ADDENDUM NO. 002

RE: Bristol Community Health Center, Phase I Renovations
For Southwest Virginia Community Health Systems
T&L Project No. 16493

DATE: April 4, 2023

Sheet No.
A601

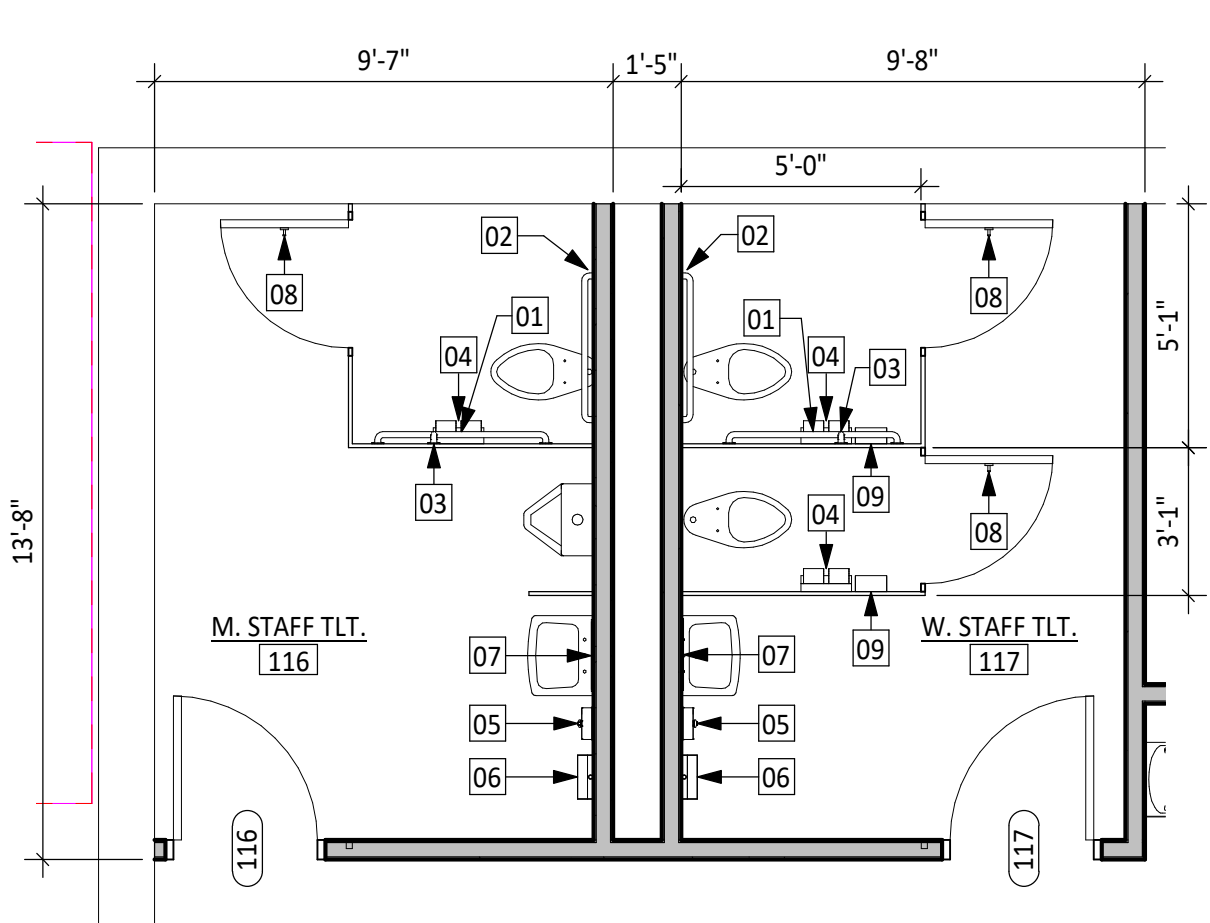
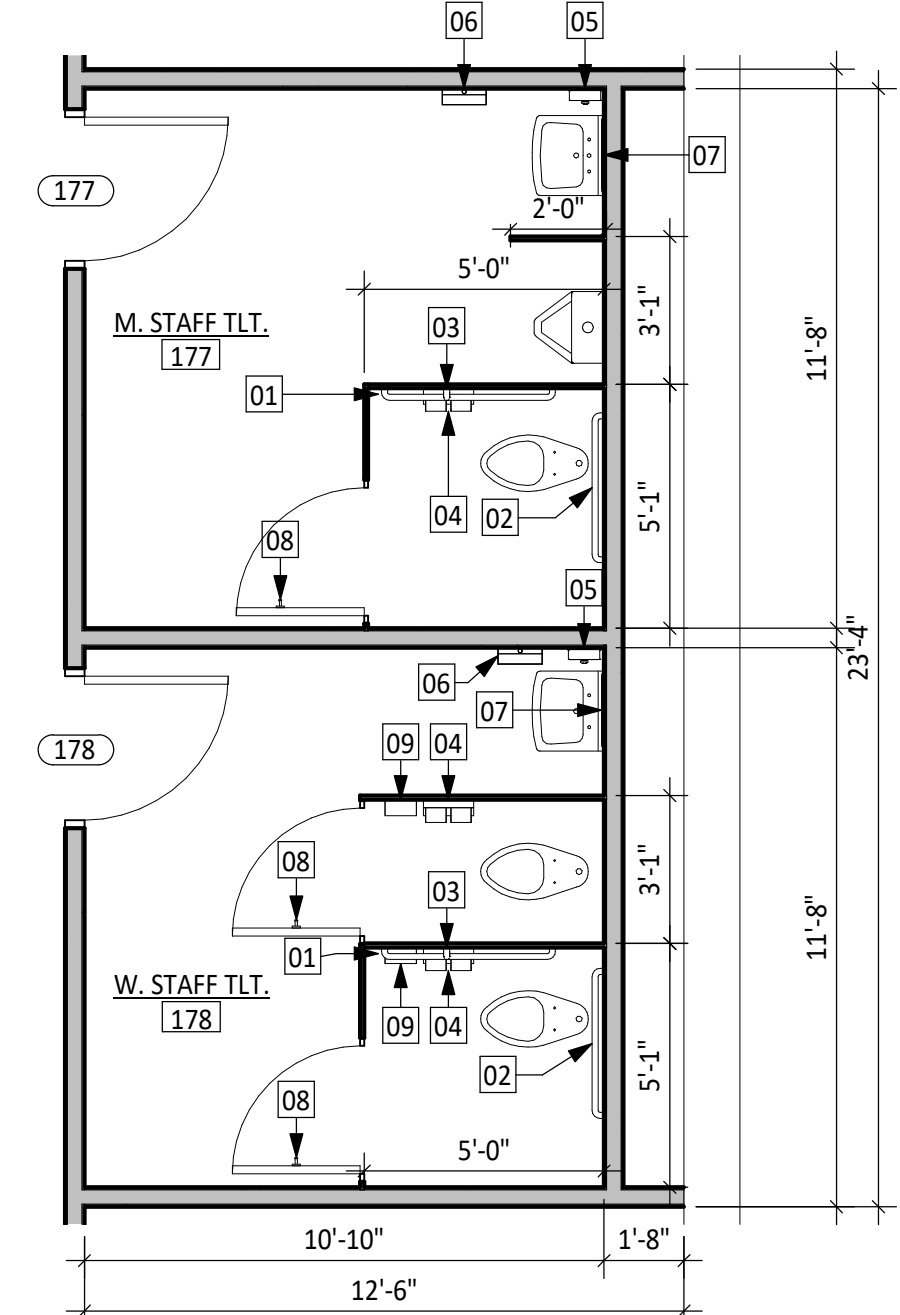
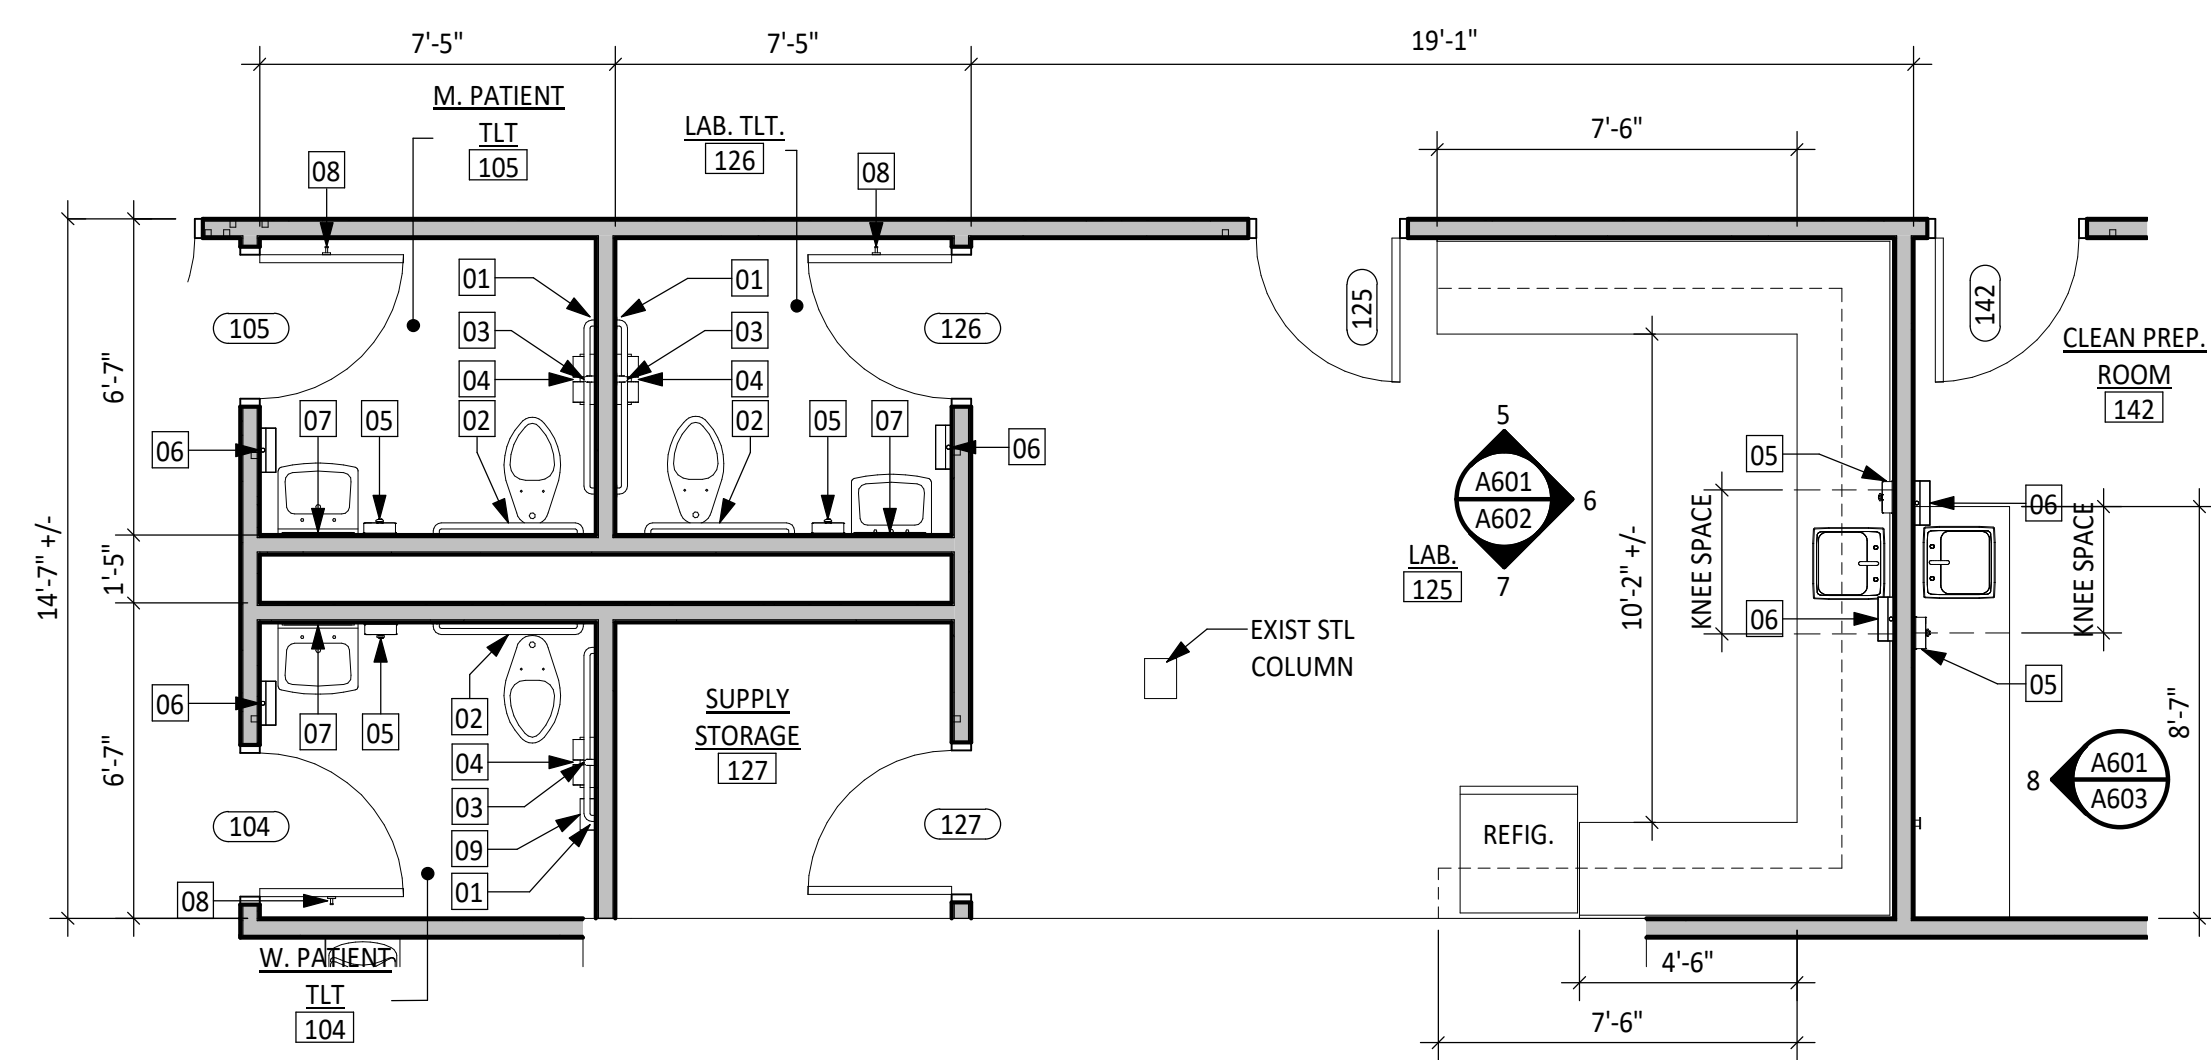
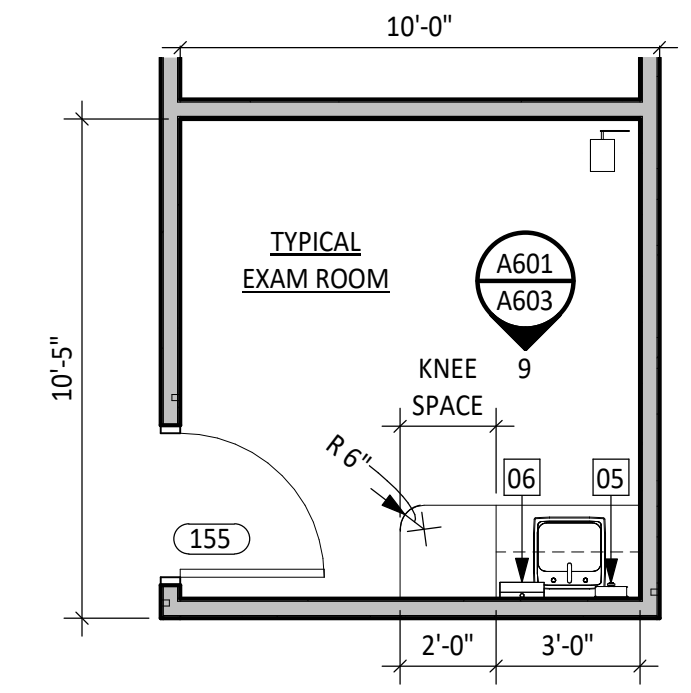
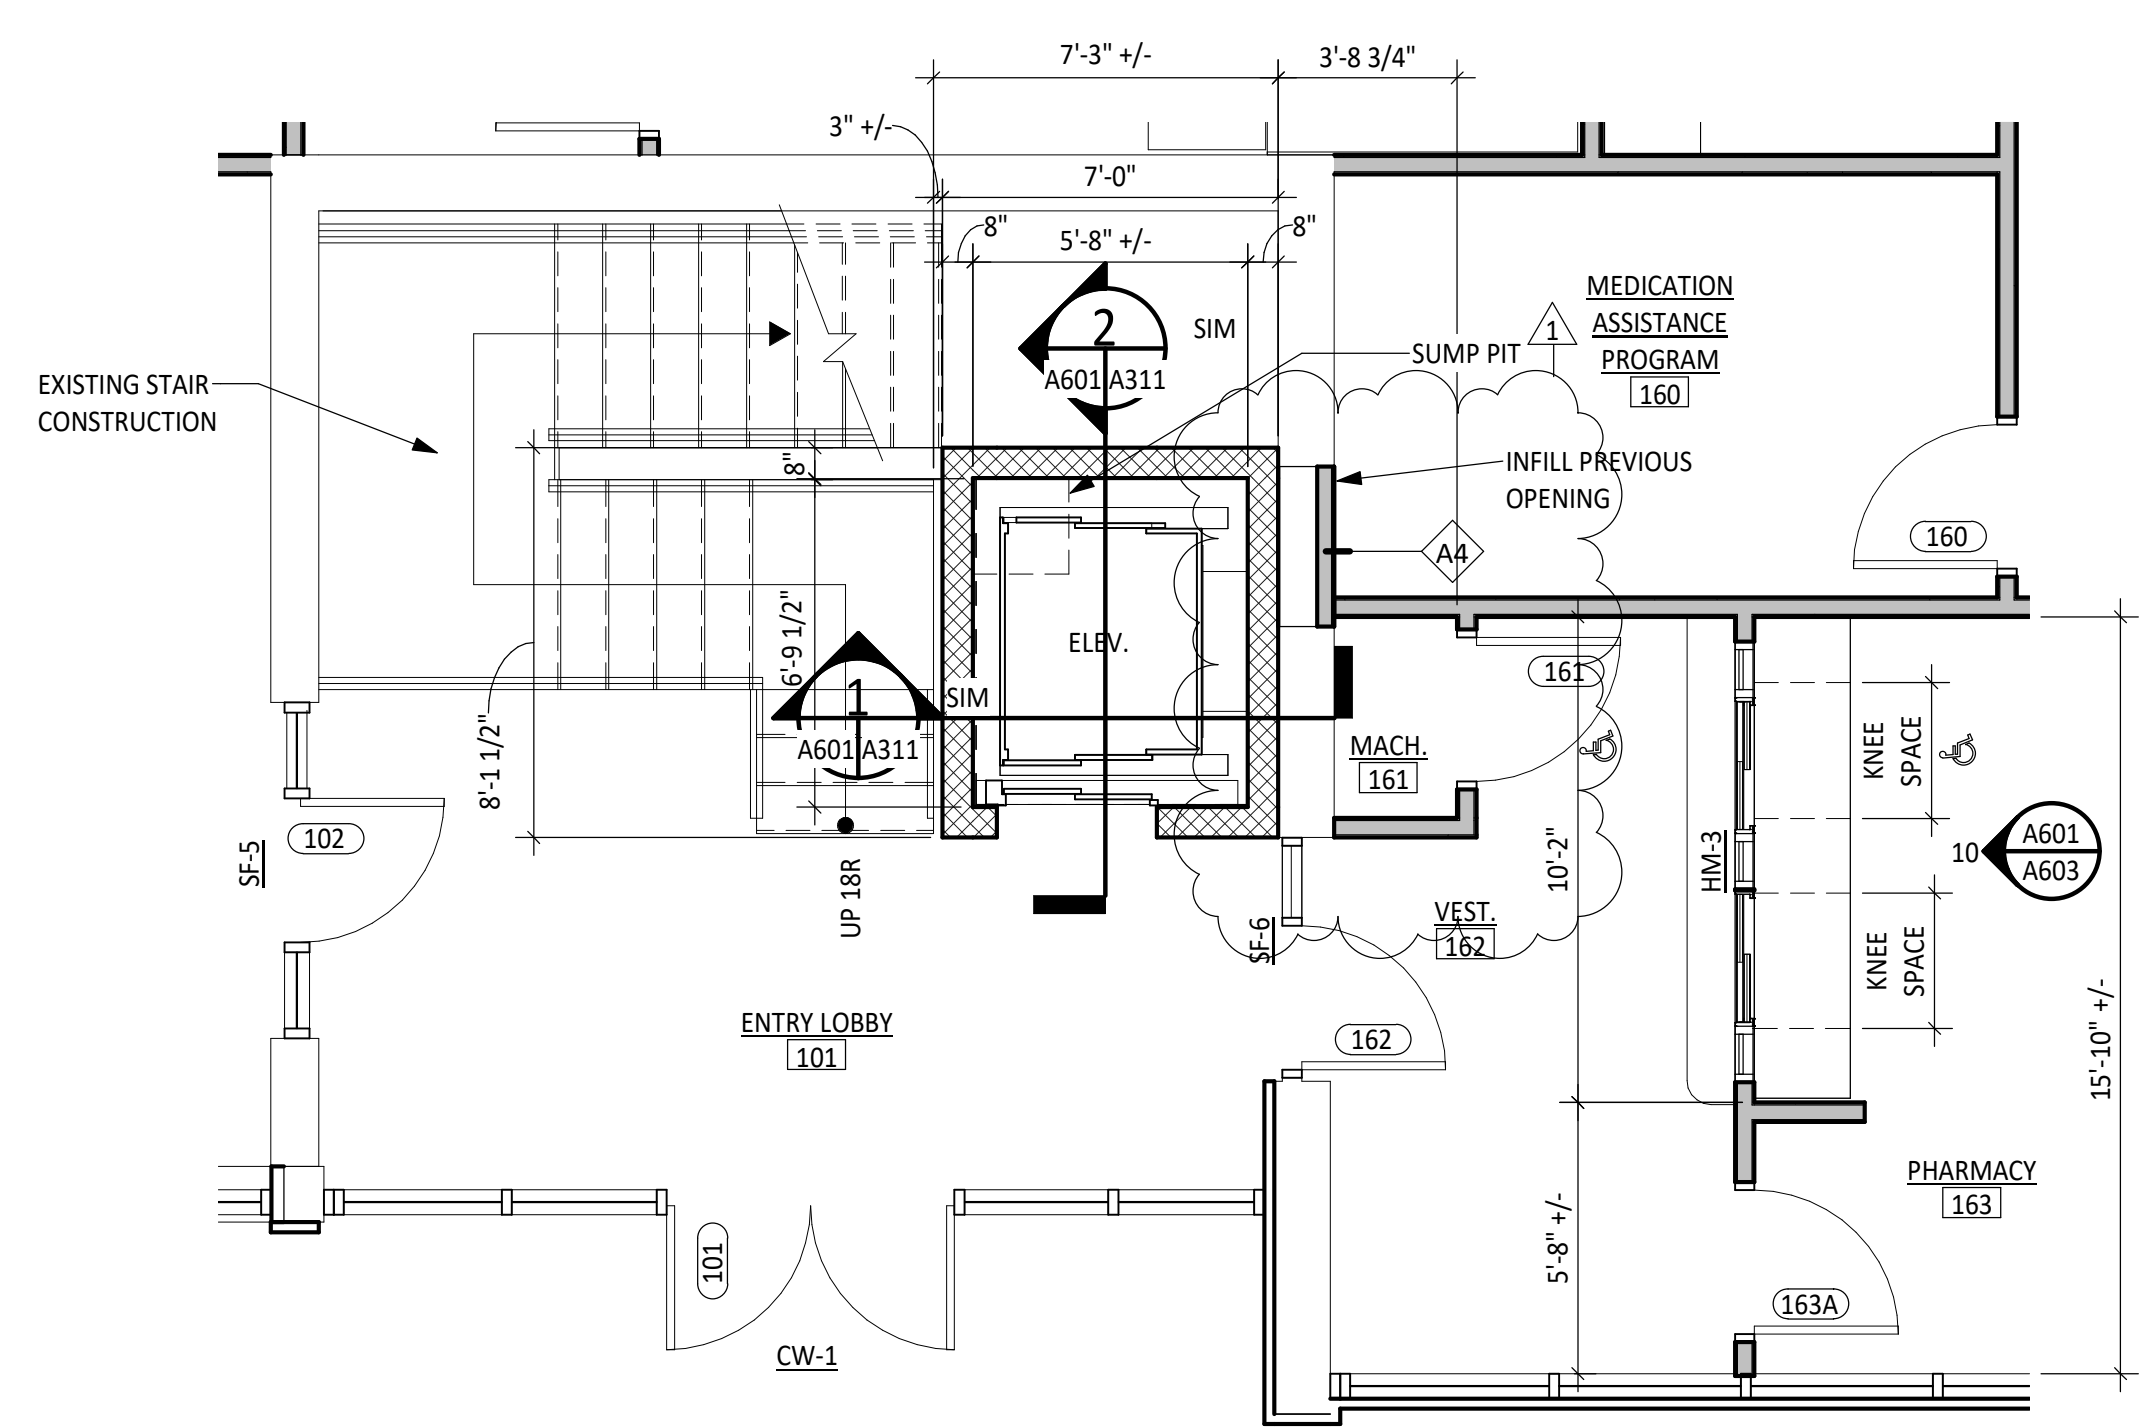
4. Refer to Drawing A103 for revisions to reflected ceiling at relocated elevator Machine Room 161 and Vestibule 162.
5. Refer to Drawing A601 for revisions and clarifications at elevator and machine room.
6. Refer to Drawing A201 for revised number and spacing of Aluminum Storefront Elevation (SF-4) and locations of wall cap WC-1, and louvers L-1 & L-2.
7. Refer to Drawing A701. Add new note no. 9 to General Partition Notes that reads, "Provide new 2-1/2" metal Z-furring at Partition Type A0.
8. Refer to Drawing A713 for revised Aluminum Storefront Elevation (SF-4).
9. Refer to Drawing S001 for "Typical Detail – Slab Replacement @ Utility Trench" and "Typical Detail – New Window Opening Existing Exterior Wall".
10. Refer to Drawing S100 for revised elevator shaft plan revisions.
